U.S. NUCLEAR REGULATORY COMMISSION  
REGION IV

NRC Inspection Report: 50-148/90-01 License: R-78

Facility Name: Nuclear Reactor Center  
(Defueled Bendix Pool Type Reactor)

Inspection Summary

FIGURE 1  
 LOCATION OF AREAS  
 DESIGNATED "SOUTHWEST"  
 AND "SOUTHEAST" SURVEYED

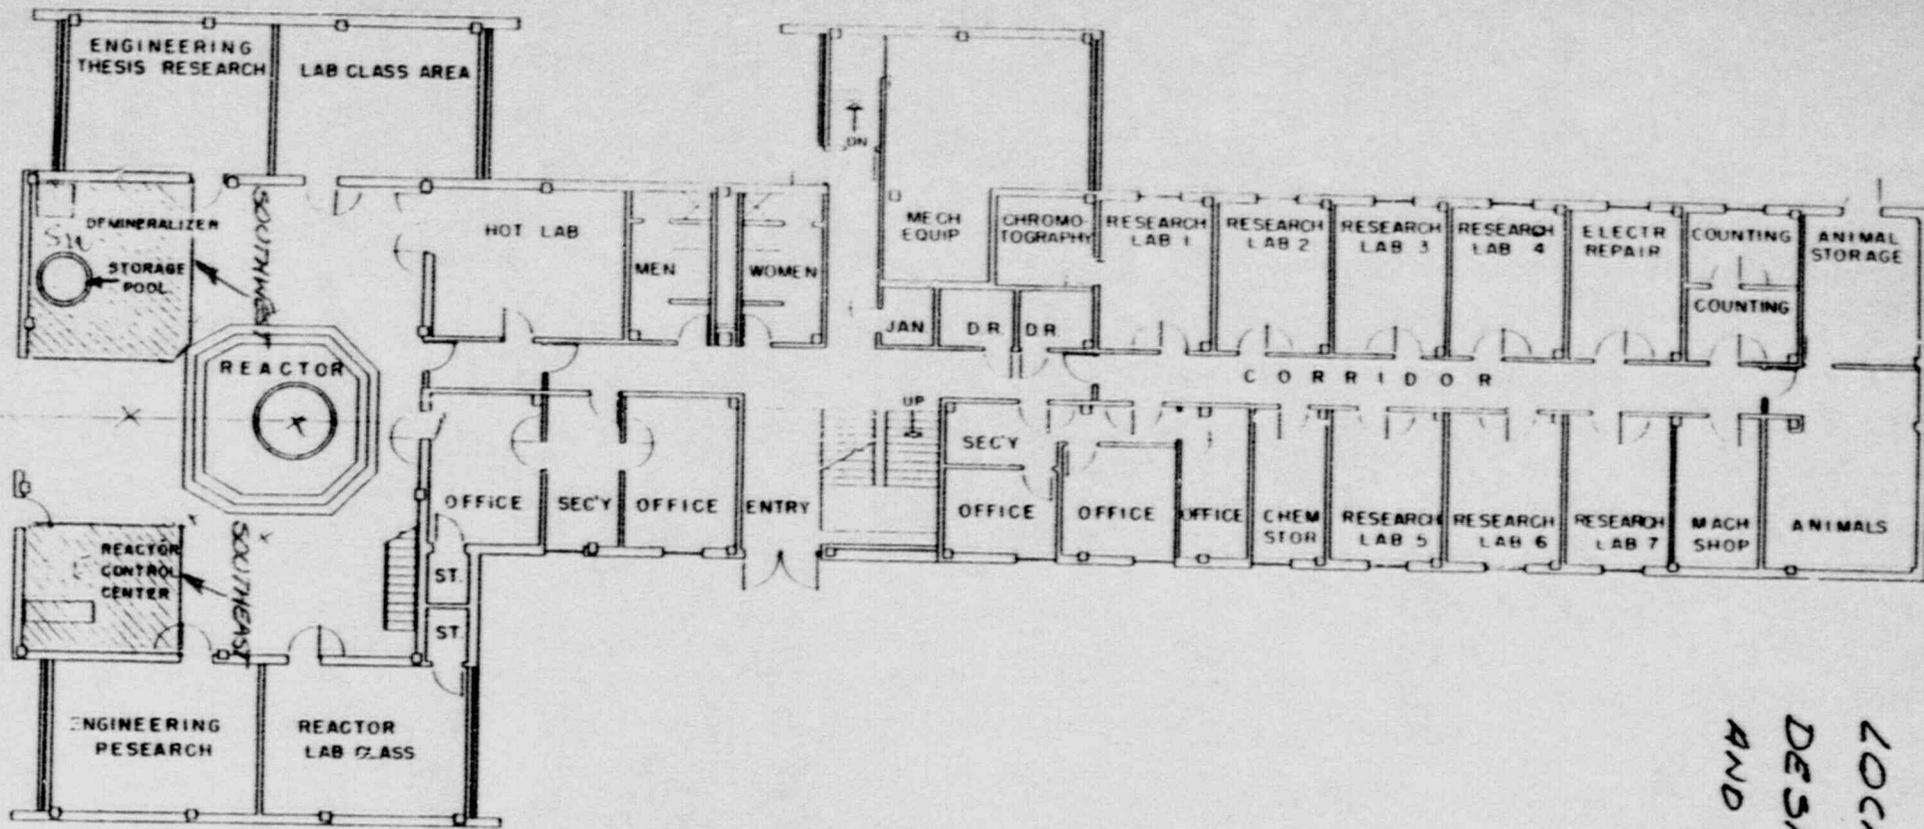
The inspector performed a verification survey of the areas depicted in Figure 1 of the nuclear reactor building. This survey was performed to independently verify the radiological status of the area. The radiological surveys performed included direct measurements of beta and gamma radiation levels. Measurements of removable (transferable) and nonremovable alpha and beta contamination were also made. All components except the aluminum storage pool liner had been removed from these areas.

The inspector determined that the general background direct gamma radiation levels associated with the facility were 7 to 10 uR/h inside the storage pool liner and 10 to 14 uR/h on the operating floor level. The inspector also verified that the maximum residual gamma radiation levels were not greater than the general background levels. No localized "hot spots" were identified. In addition to gamma measurements, the inspector also performed surveys to identify fixed beta radiation levels. One small area, less than 100 square centimeters (100 cm<sup>2</sup>) was identified where radiation levels were approximately 350 counts per minute above background. This area was decontaminated to background levels before the inspector left the facility.
